Application for Third Amendment to  
Siting Certificate for Hog Creek Wind Farm LLC  
Hardin County, Ohio

Case No. 16-1422-EL-BGA

**Re: Hog Creek Wind Farm LLC,  
Case No. 16-1422-EL-BGA**

**Figure 02-1 Project Schedule**

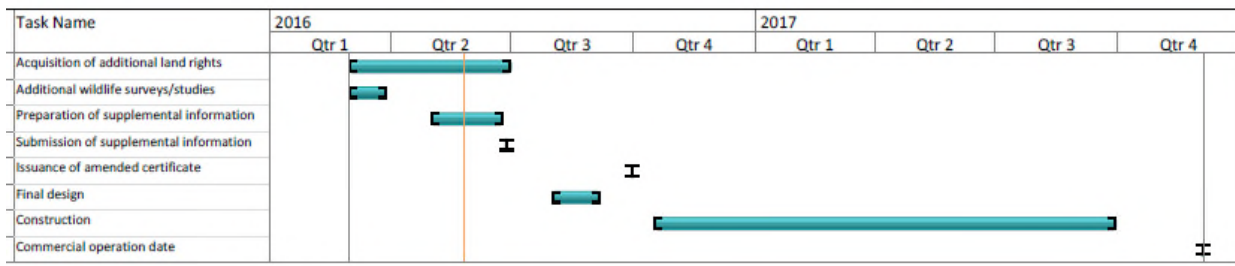
A new Combined Project schedule is provided as Figure 02-1.
